Technical Note

Project No: ITB11347
Project Title: Mill Lane, Hatfield Heath
Title: Response to ECC Consultation: UTT/22/1261/FUL
Ref: ITB11347-008A TN
Date: 4 November 2022

4.2 As outlined previously, the proposals for the terrace housing have been removed and therefore these points are no longer relevant for the application.

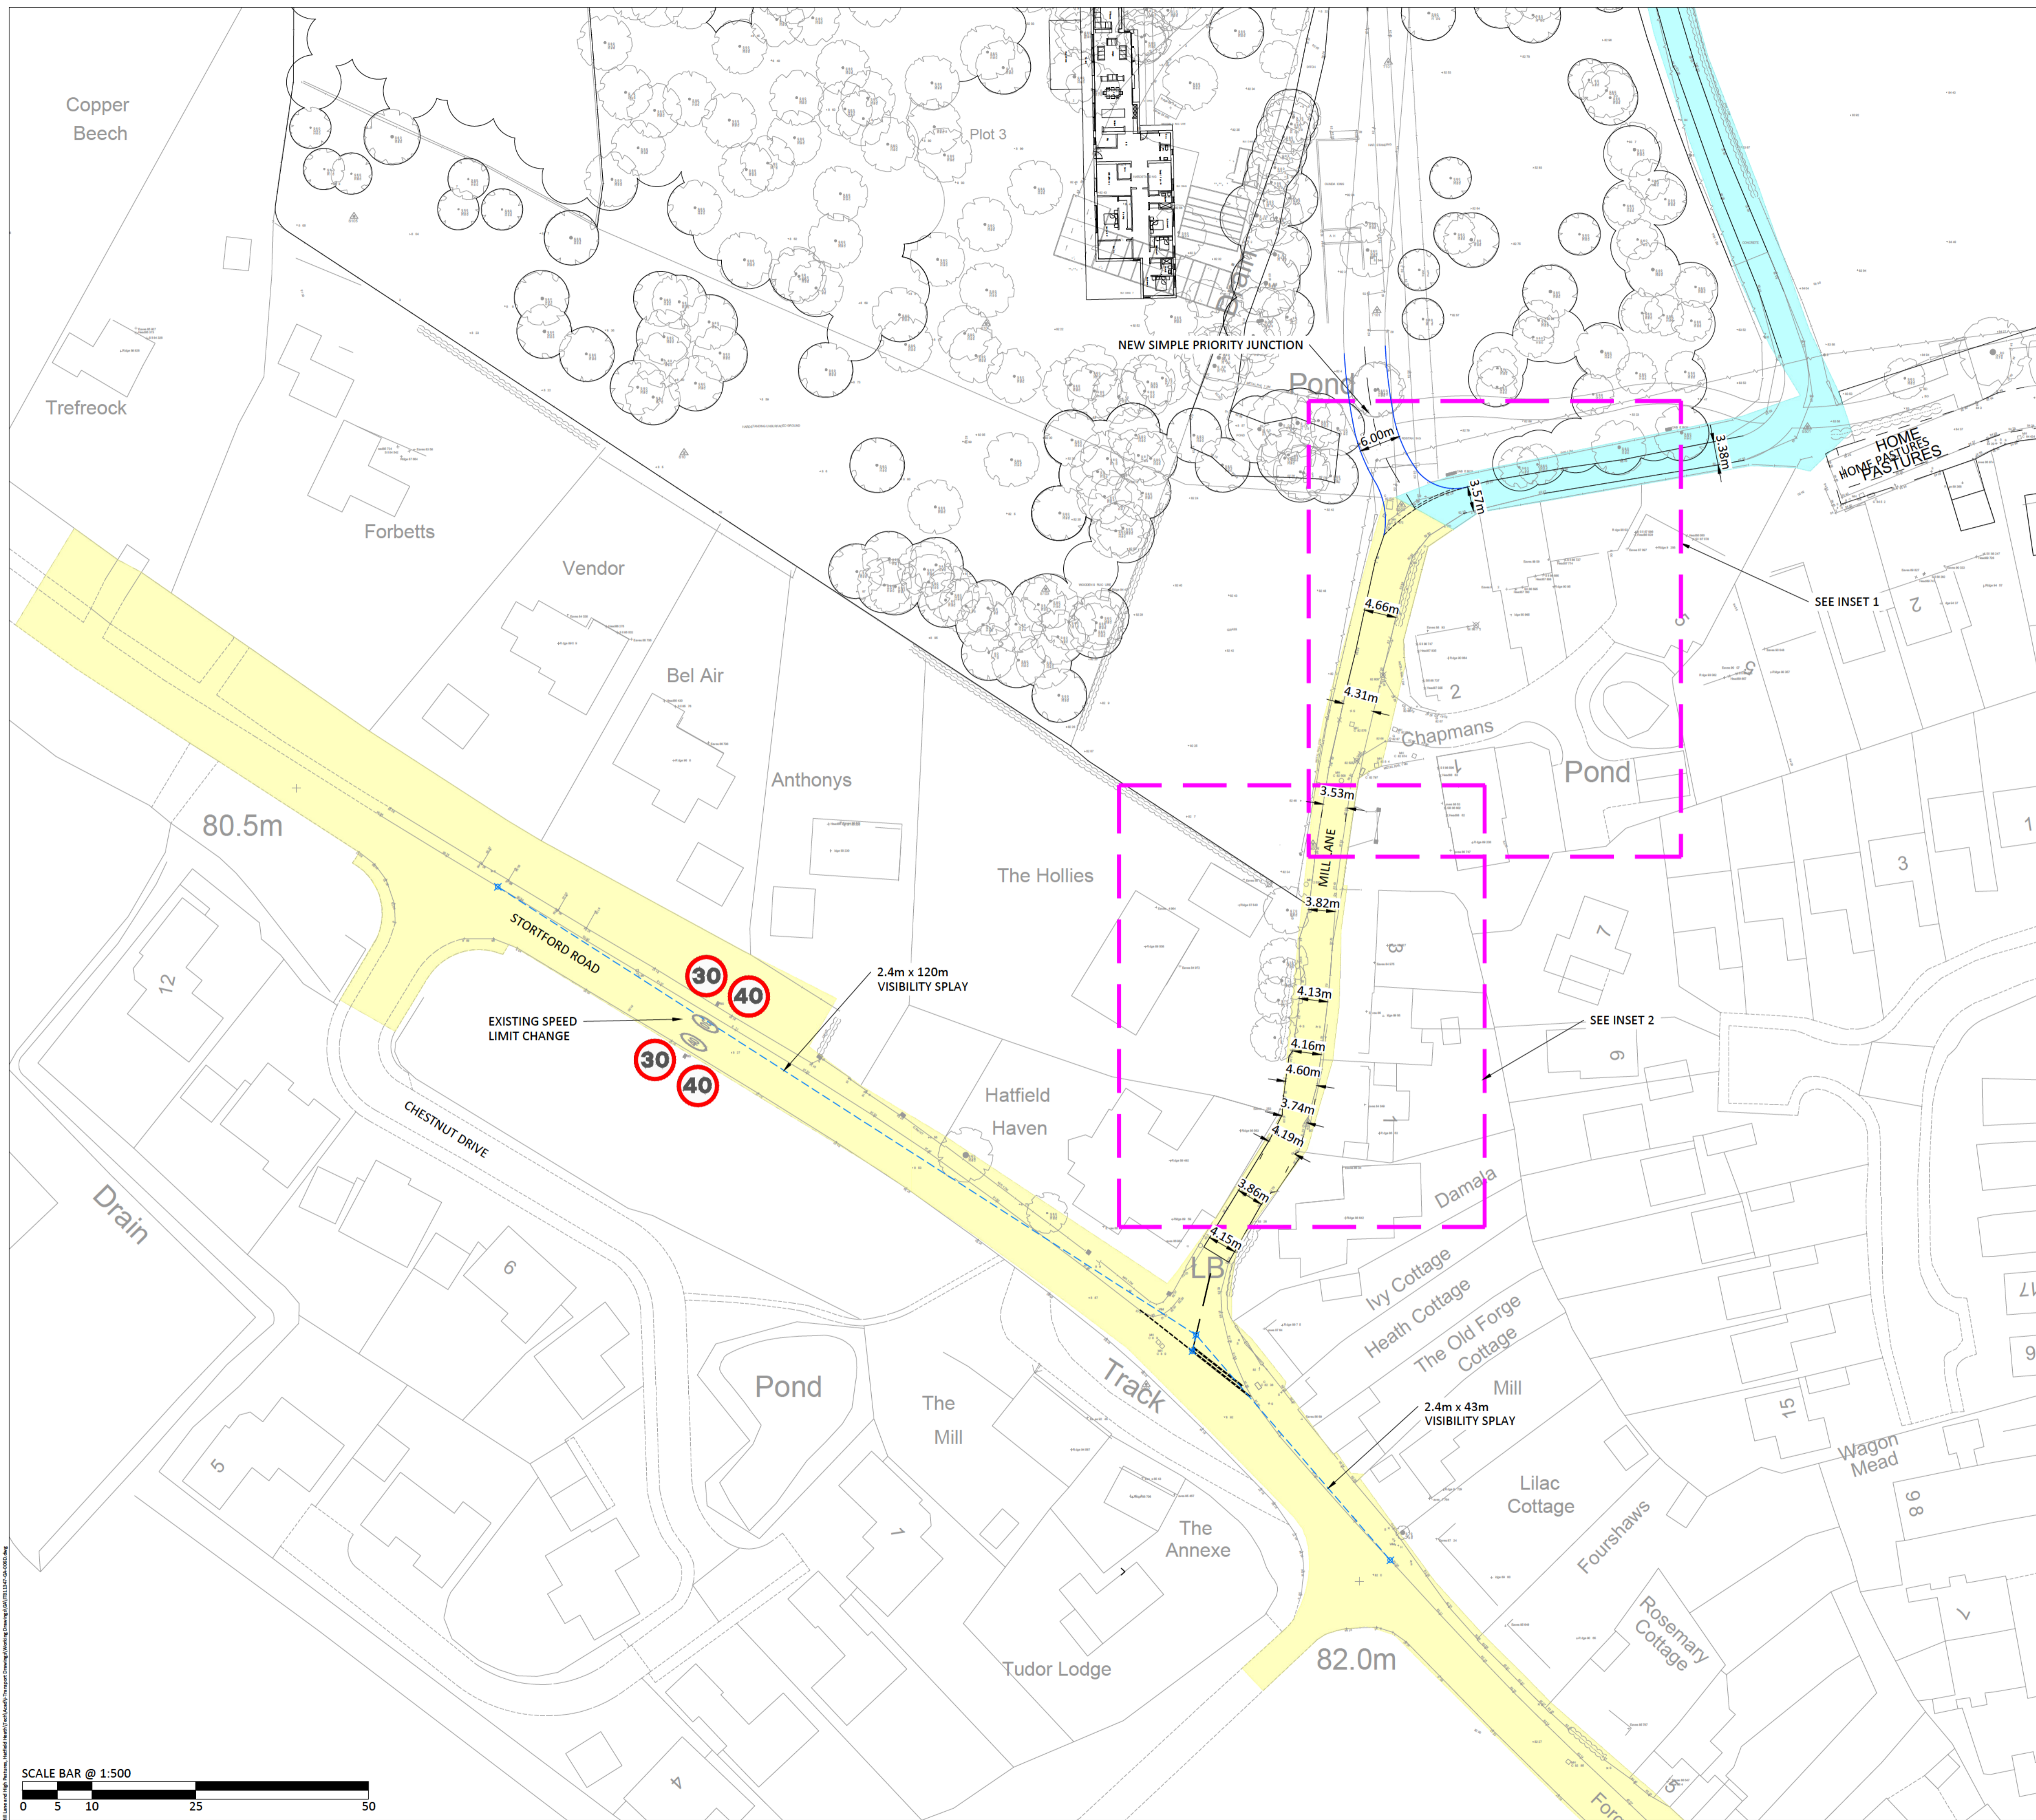
2.3.1 ECC have outlined that Mill Lane has deficiencies in geometric layout and visibility and at points falls below 4m in width, not allowing two cars to pass.

- 3.1 ECC have identified four points under this section, set out as follows:
- a* Visibility splays from the junction of Mill Lane with Stortford Road should be provided.
 - b* Visibility splays from the access to the terraced housing should be provided in accordance with the guidance in *Manual for Streets*.

2.3.2 There are instances where Mill Lane does fall below 4m, but for the majority of the length of Mill Lane the width is 4.1m or greater as demonstrated in drawing ITB11347-GA-006 Rev D provided in the drawings section at the end of this note. Manual for Streets (MfS) demonstrates that roads which are of 4.1m in width allow two cars to pass. Therefore, for the majority of Mill Lane between Stortford Road and the proposed site access, cars can pass each other.

2.3.4 In relation to sections 1 and 3, these are very limited sections of the lane and are located on "straights" and immediately either side are sections of wider carriageway, which allow two cars to pass. As these very short sections are located on "straights," generous intervisibility between vehicles approaching them is achieved and is shown in Inset 2 on Drawing ITB11347-GA-006 Rev D.

3.2 In regard to point (a), this was shown in Drawing ITB11347-GA-006 Rev B in the Transport Statement. Drawing ITB11347-GA-006 Rev D provided in the drawing section at the end of this note, makes the visibility clearer, but as per the Transport Statement, the visibility shown achieves 120m to the north - which is the requirement for a 40mph speed limit, whilst the junction is located in a 30mph speed limit, which would require a 43m visibility requirement, which is the visibility shown to the south of the junction.

DRAWING No: **ITB11347-GA-012**
 PROJECT No: **ITB11347** REV:

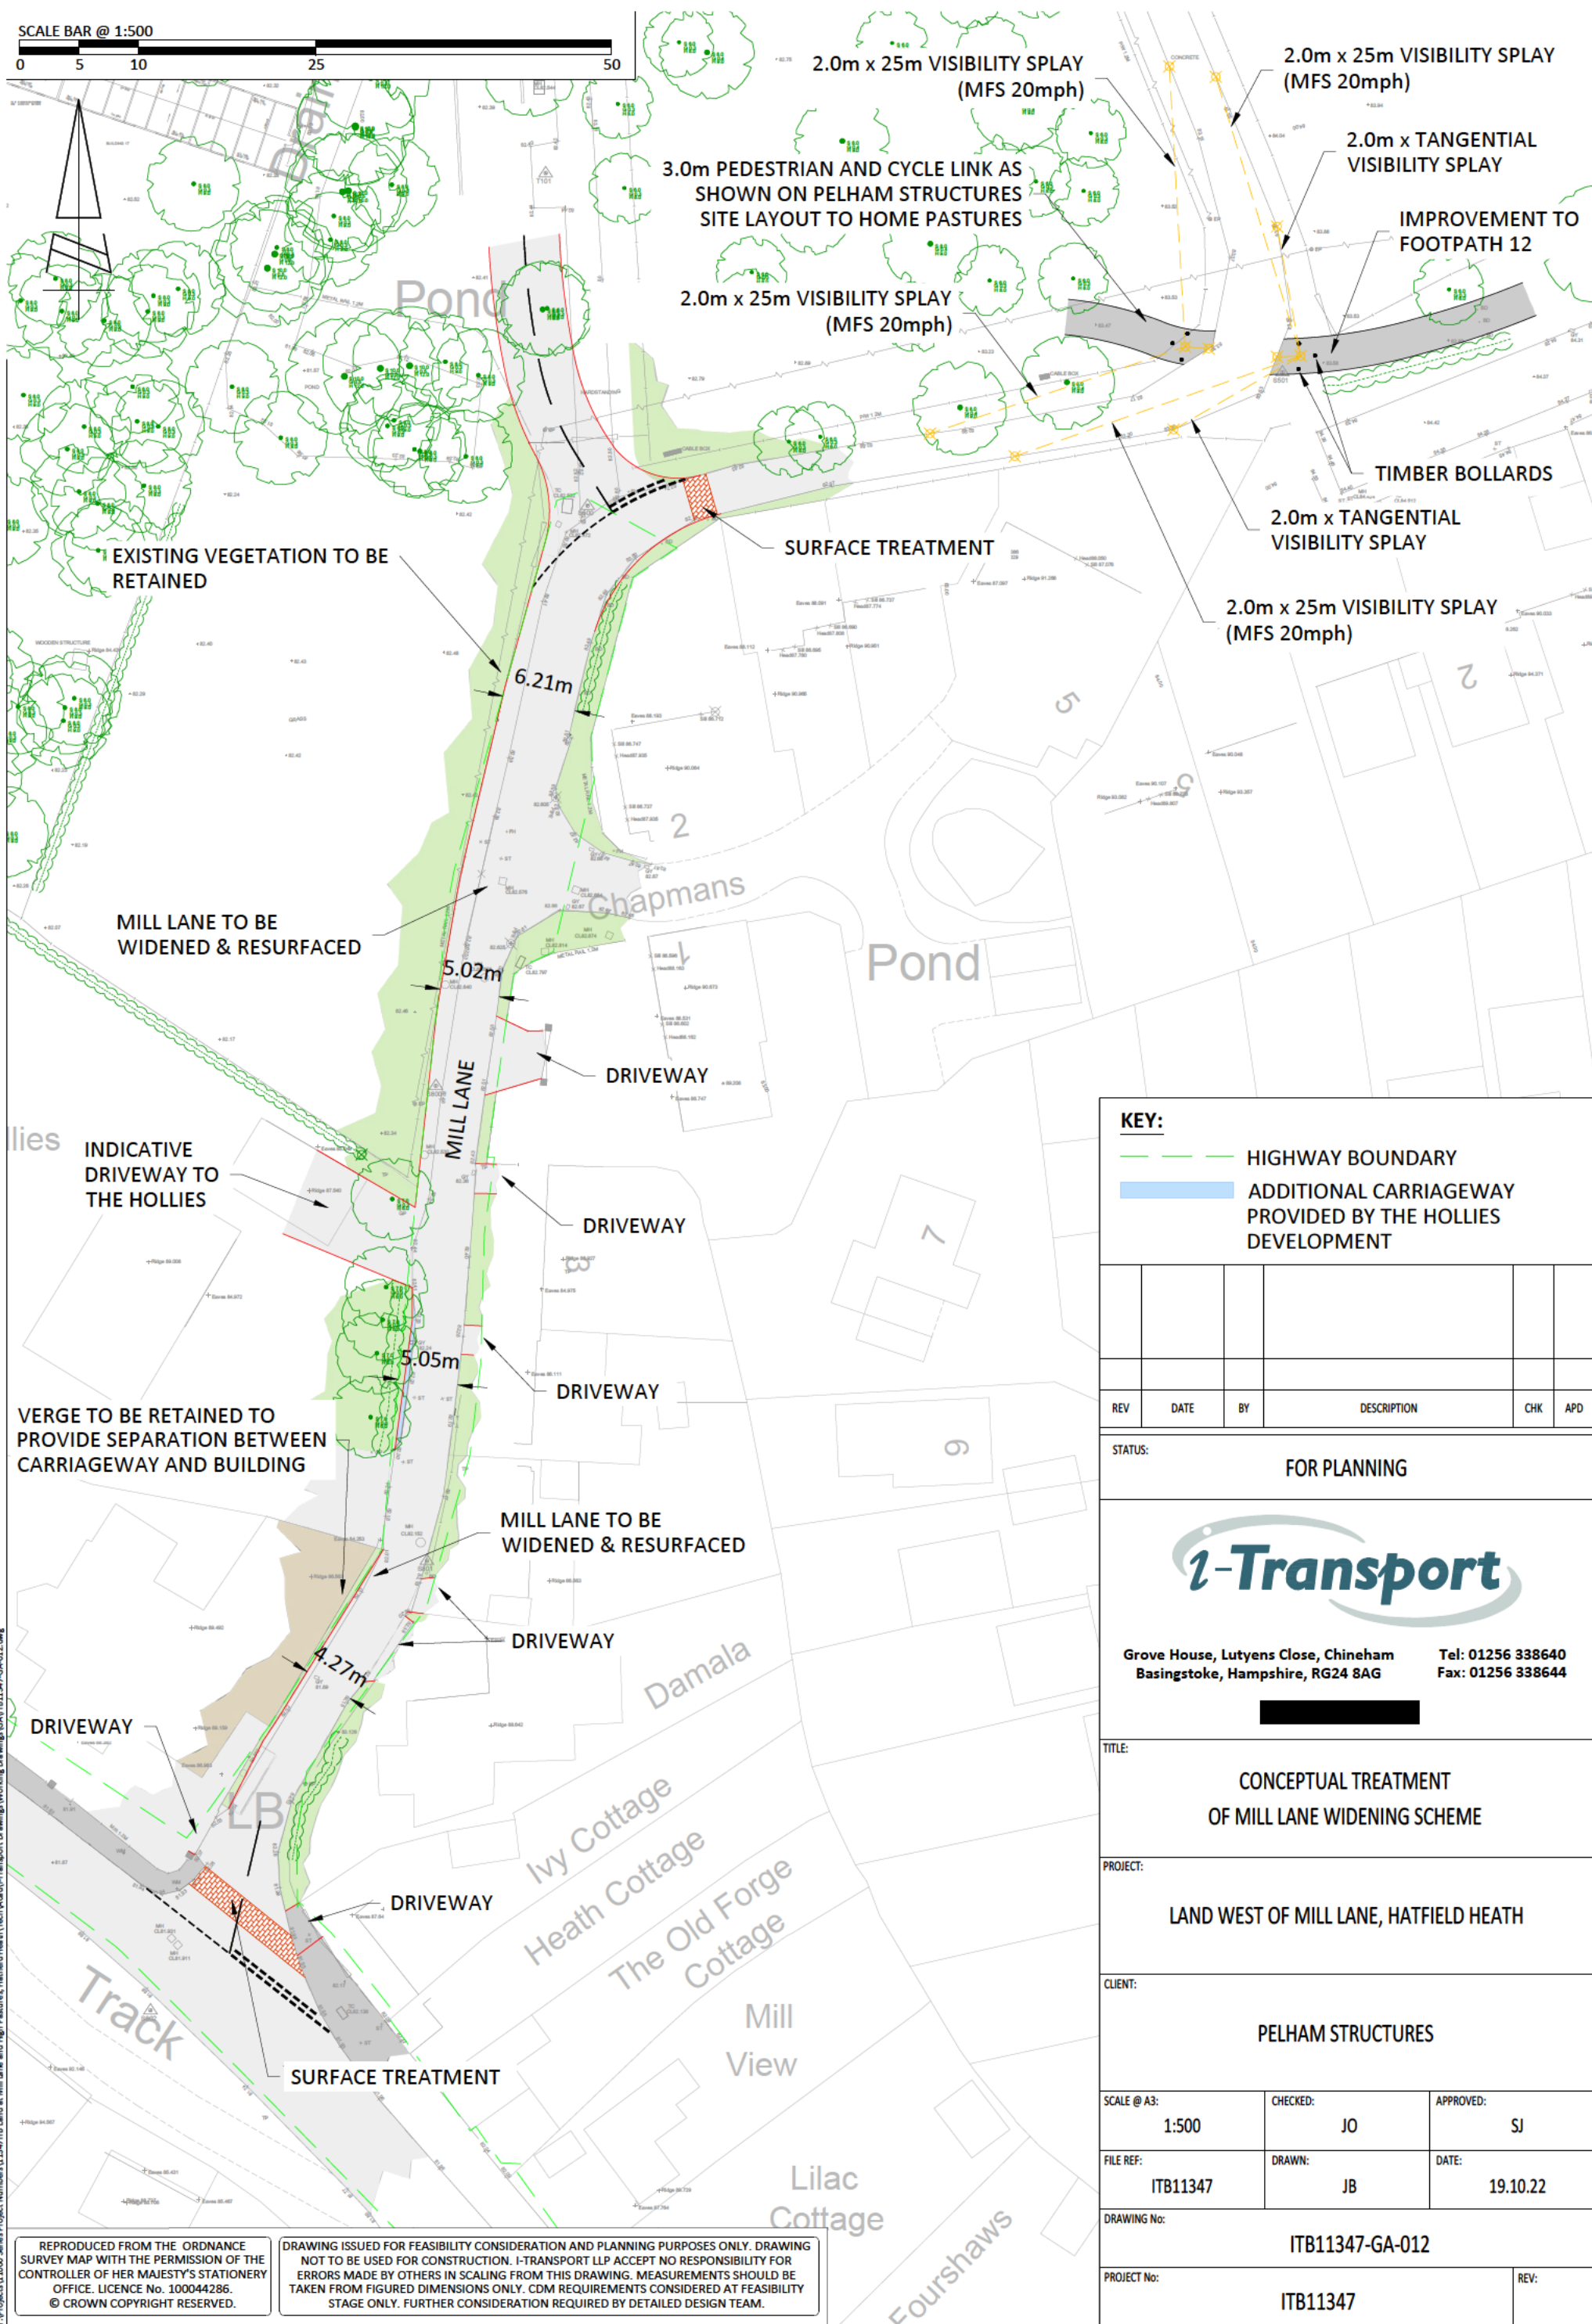
- 2.5.1 ECC outlined that the proposed pedestrian facilities do not serve the whole length of Mill Lane and so pedestrians, cyclists and vehicles all share a limited space which could lead to conflict and adversely impact on pedestrian safety.

2.4.1 Notwithstanding the above, the applicant is prepared to provide improvements to Mill Lane, which consist of the following and are shown in Drawing ITB1347-GA-012 provided in the drawing section at the end of this note:

- Surface treatment when entering Mill Lane;
- Widening of Mill Lane to the west prior to the first bend along Mill Lane, providing a 0.3m verge between the carriageway and existing building.
- Widening of Mill Lane to the west to the extent of the highway boundary from north of the 'Hollies' to the proposed site access.
- Smoother radii on Mill Lane opposite the site access.
- Street treatment to the east of the proposed site access.
- Resurfacing of Mill Lane.

2.4.2 The scheme of improvements shown conceptually on drawing ITB11347-GA-012 can be secured in a Grampian style planning condition and delivered by the applicant should this be required by ECC Highways.

DRAWING No: ITB11347-SK-001	REV: G
PROJECT No: ITB11347

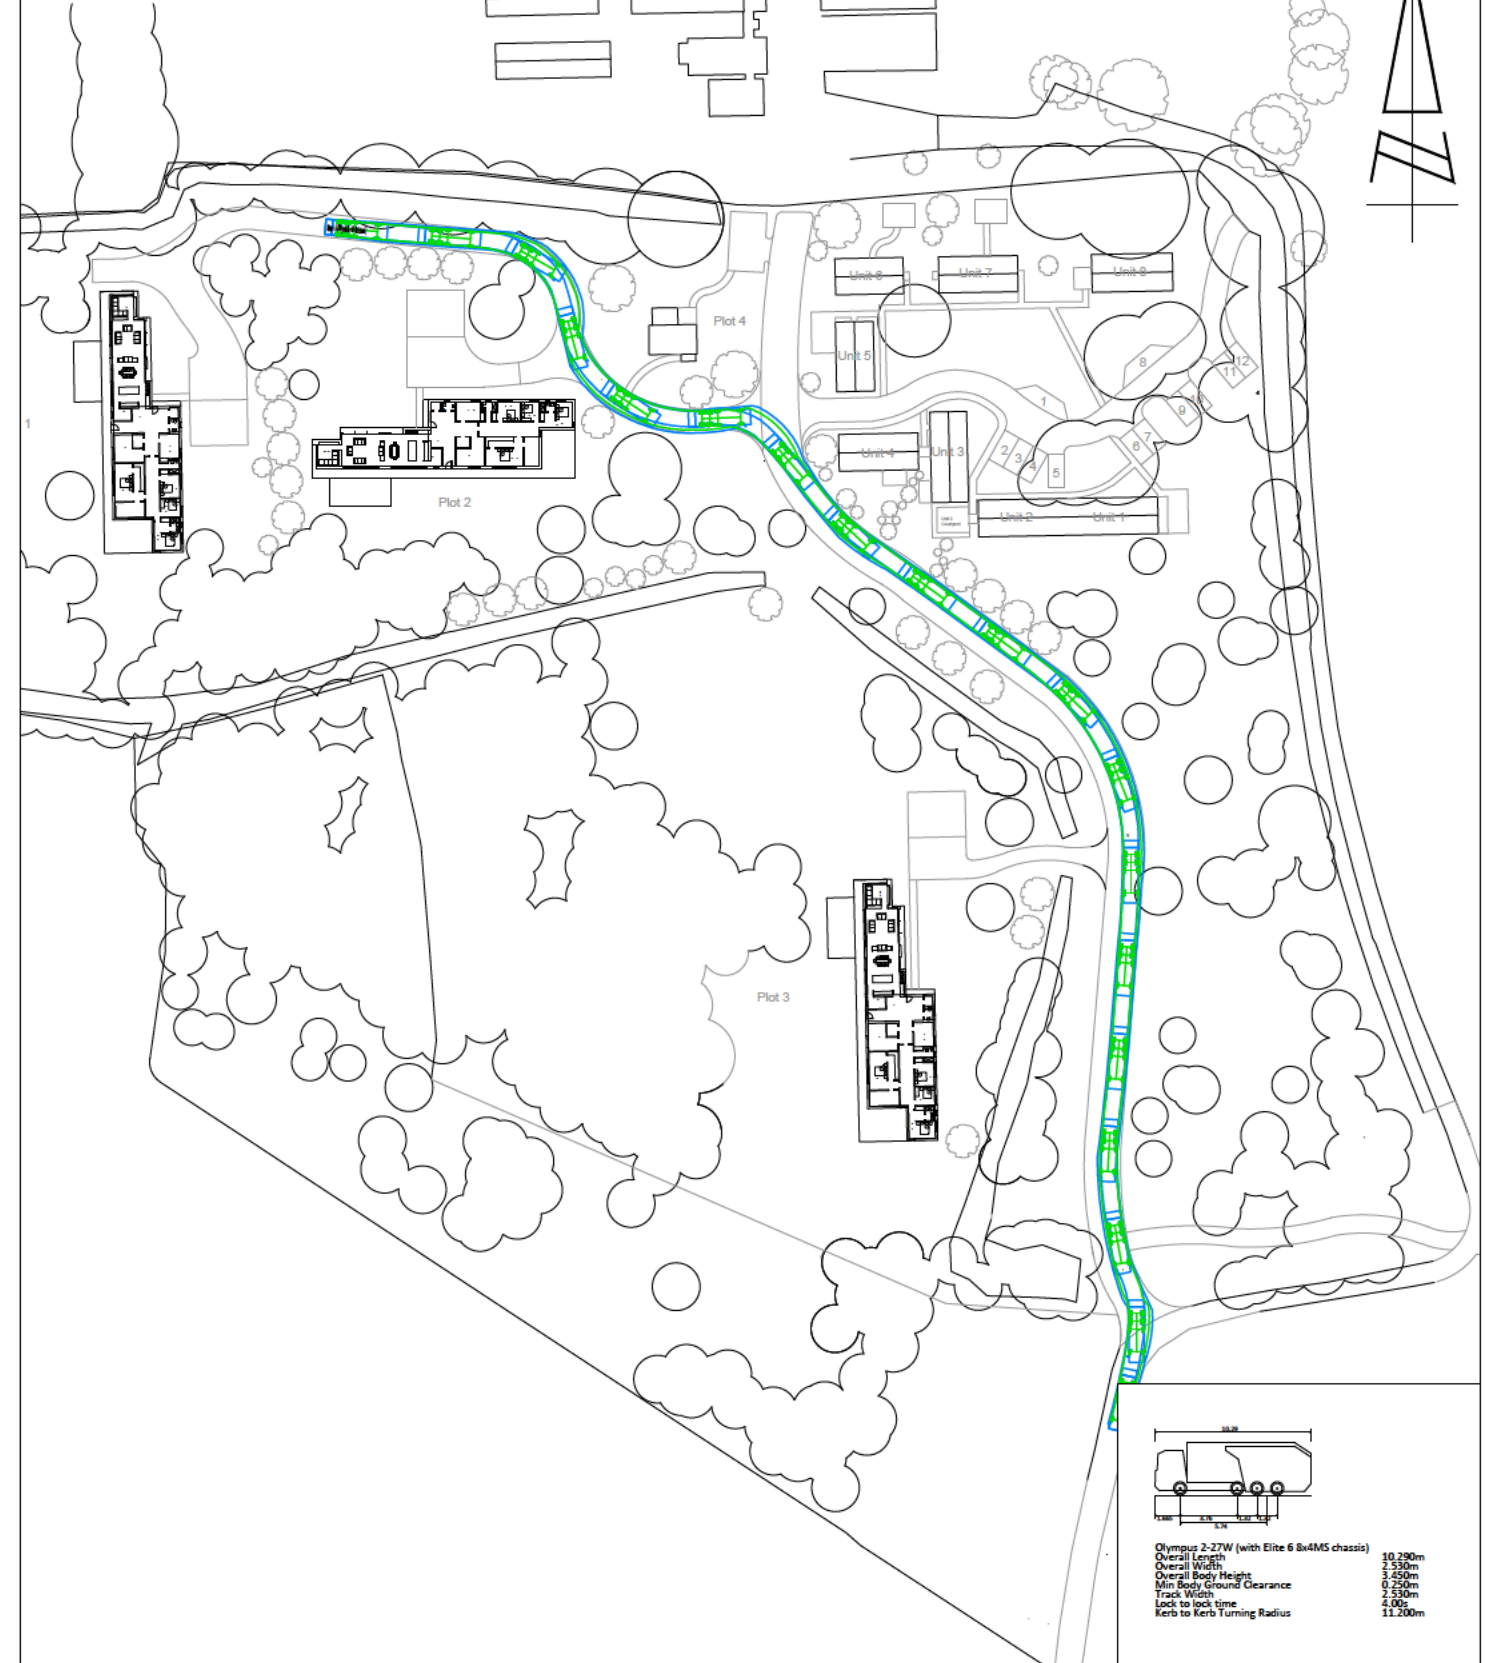
- c Swept path analysis for a large car and a van should be provided for the access to the terraced housing.*
- d The swept path analysis for a refuse vehicle has been provided for the site but it uses a vehicle of a smaller length than that used by UDC refuse team. This should be repeated with correct vehicle, which has a length of 10.325m and a turning circle of 22.4m, the speed of the vehicle should be provided and should be a reasonable speed for the type of road.*

3.4 The update to the refuse vehicle tracking using ECC's suggested vehicle has been undertaken as per point (d) and is shown in Drawing ITB11347-SK-001 Rev G and Drawing ITB11347-SK-002 Rev C. The swept path analysis shows that the revised refuse vehicle can enter, manoeuvre and turn within the site and exit the site in forward gear along the main access road.
